October 19, 2010

FROM: Alan Dippy, Chair, Durham Bicycle and Pedestrian Advisory Commission

Subj: NC54 Corridor Study- Draft Report

Figure 1

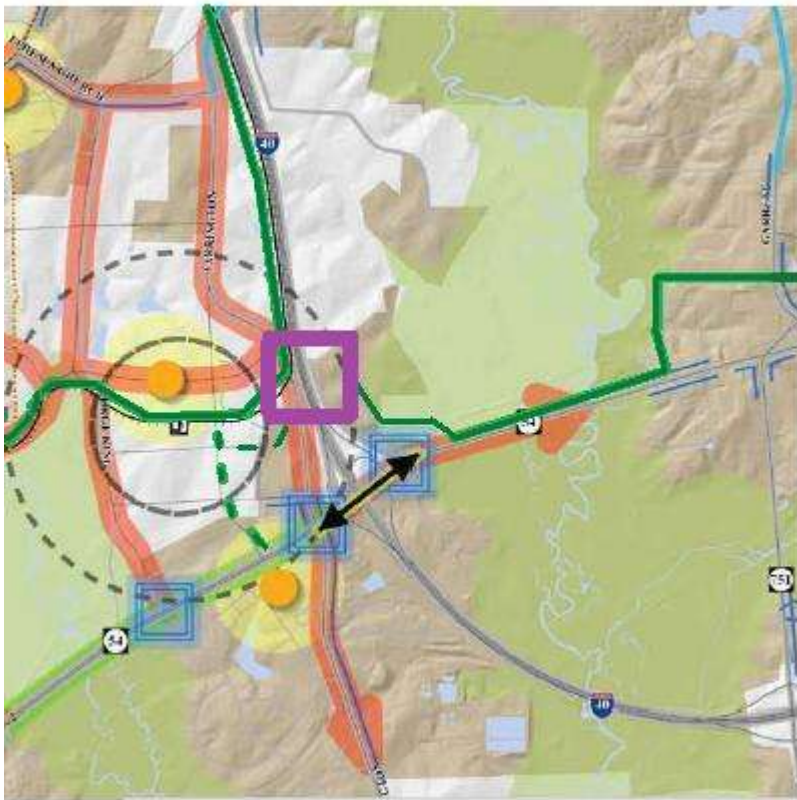
- The Bike Plan shows a connection on the north side of NC54 between the Third Fork Creek Trail and the project area. This connection would likely be achieved by installing a side path along NC54 between Biscayne and Leigh Farm Park Road as part of a future widening. This planned facility and existing Third Fork Creek Trail should be mentioned in the report and shown in its maps, as was done with the Bolin and Battle Creek greenways in Chapel Hill. Please refer to Figure 1 below.

- A pedestrian bridge north of the I-40 interchange is mentioned in the report, but we believe there should be a more concrete recommendation, as this will serve as a critical link between the NC54 multi-use trails and the connection to Third Fork Creek Trail. Please refer to Figure 1 below.

- Trails on both sides of I-40 should arc northward to meet this bridge and to avoid the complicated I-40/Farrington interchange [figure 1].
- We would like to see a detailed plan for how pedestrians and bicyclists can safely access the bus stops and how the stops would be made ADA-accessible. Considerations should be made for accessible pathways to the bus stops themselves from nearby sidewalks/multi-use paths, providing safe crossings across NC-54 (most transit passengers board the bus across the street from the stop they alight), and providing safe and comfortable locations for the passenger to wait for and board the vehicles.
